Urban Design Review Panel Comments and Applicant Response

Application number: DP2018-2769

Municipal address: 114, 116, 120 3 Av SW, 117 2 Av SW

Project description: Mixed Use Development

<p>③ ENLARGED PARTIAL NORTH ELEVATION NOT TO SCALE</p>  <p>④ ENLARGED PARTIAL SOUTH ELEVATION NOT TO SCALE</p>															
3

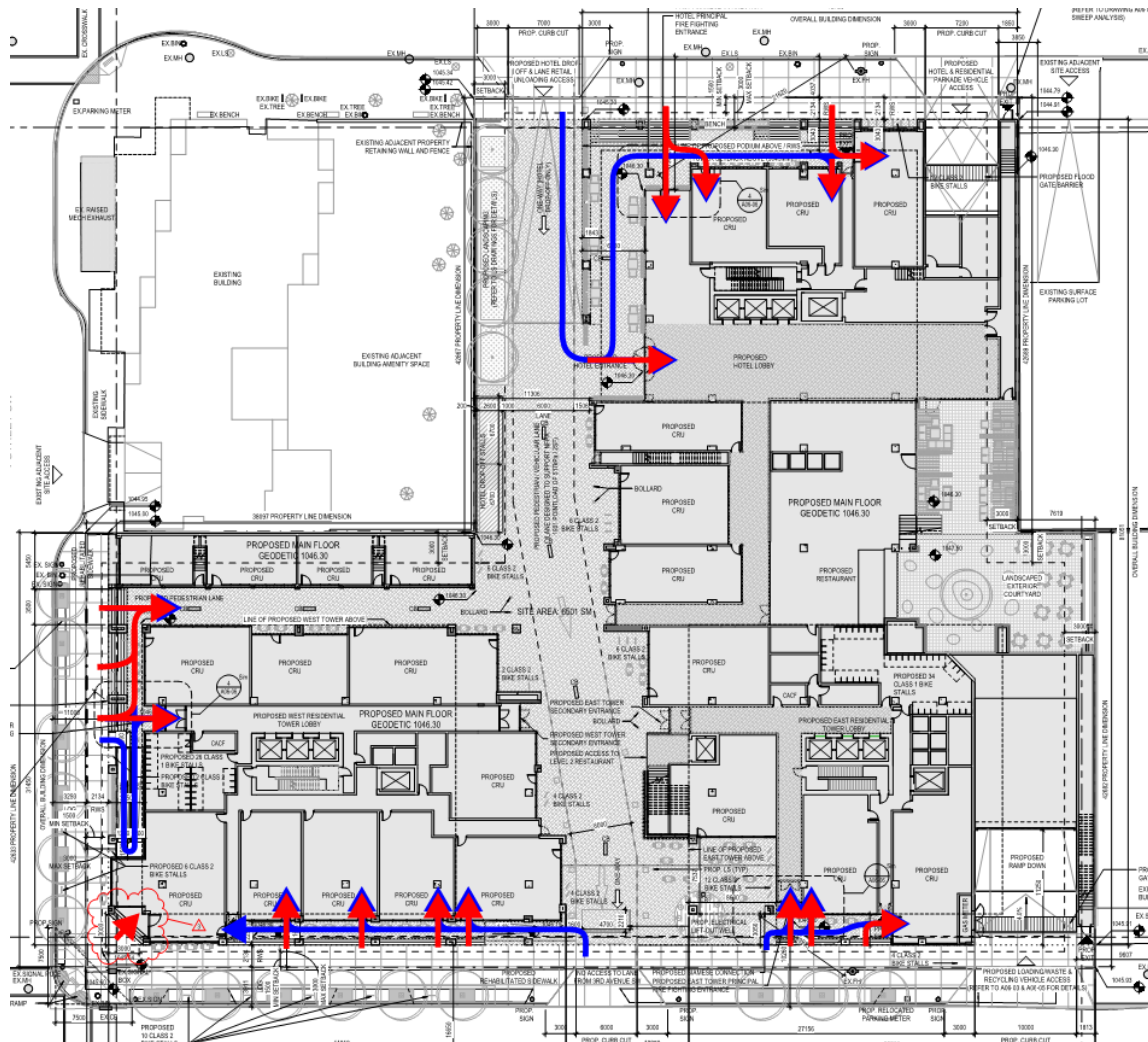
Urban Vitality			
	Topic	Best Practice	Ranking
1	Retail street diversity	Retail streets encourage pedestrians along sidewalk with a mix and diversity of smaller retail uses. Retail wraps corners of streets. Space for patios and cafe seating is provided.	Support
	UDRP Commentary		
	Applicant Response		
2	Retail street transparency, porosity	Retail street maximizes glazing - 70% and more. Maintains view into and out of retail, avoids display-only windows.	Further Review Recommended
	UDRP Commentary		
	Renderings and precedent images move in this direction; further refinement and details of street-level glazing recommended.		
	Applicant Response		
	Additional enlarged elevations indicating character, glazing and materiality of retail frontage were included as part of the responses to the DTR1 comments, see images below. Further refinement of the retail frontages will continue as the design progresses through into building permit drawings.

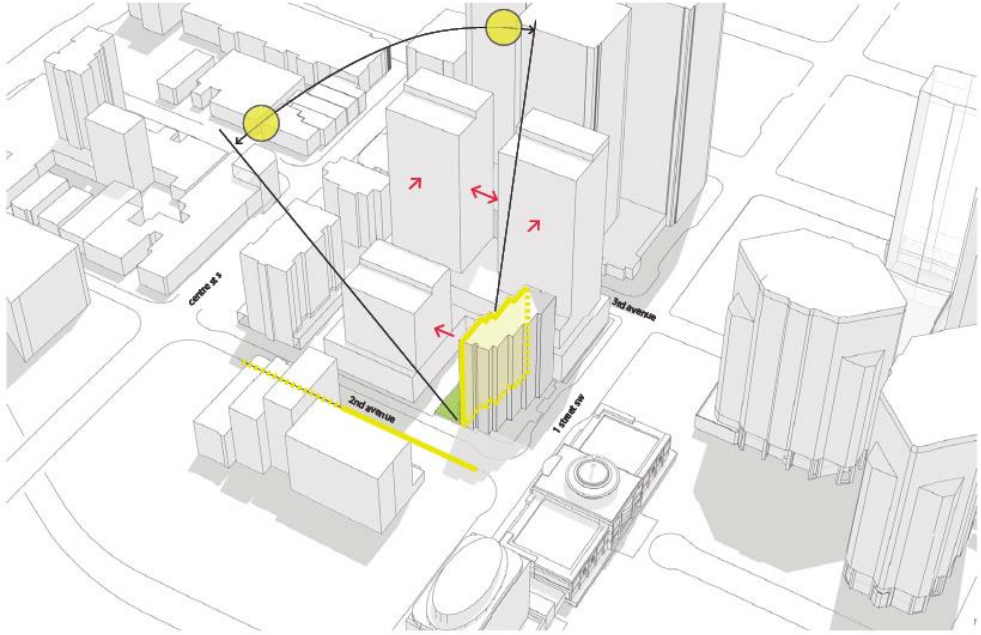
pedestrian flow between the site and the Bow River pathway system, the Panel recommends that the City and applicant review the quality of the pedestrian crossing along the east side of the 1 st Street SW / Riverfront Avenue intersection – Remains unresolved		
	Applicant Response		
	The applicant is in agreement with this comment. This issue is a larger urban neighborhood connectivity issues that currently is beyond the scope of this project. Connection to the river pathway would be a significant benefit to this development and the applicant encourages the city to develop 1 st St SW as a pedestrian friendly promenade connecting downtown to the River pathway system.		
11	Cycle path connections	Supports cycling via intentional, safe urban design connections to pathway systems and ease of access to bicycle storage at grade.	Support
	UDRP Commentary		
	Bicycle storage, racks, and routes should be specifically identified

Applicant Response		
	All Bicycle storage and racks have been identified on the site and floor plans.		
12	Walkability - connection to adjacent neighbourhoods / districts / key urban features	Extend existing and provide continuous pedestrian pathways. Extend pedestrian pathway materials across driveways and lanes to emphasize pedestrian use.	Support
	UDRP Commentary		
	The Panel notes strong connectivity and walkability, though believes a +15 connection to the hotel could enhance the overall connectivity of the site and could be explored further.		
	Applicant Response		
	The project site lies beyond the boundary of the current City of Calgary +15 zone. In addition, the City of Calgary +15 policy does not encourage connection to a residential building. The applicant is interested in providing a +15 connection to the Sunlife Towers to the south and have accommodated a connection in the current design if the +15 policy were to be updated in the future.
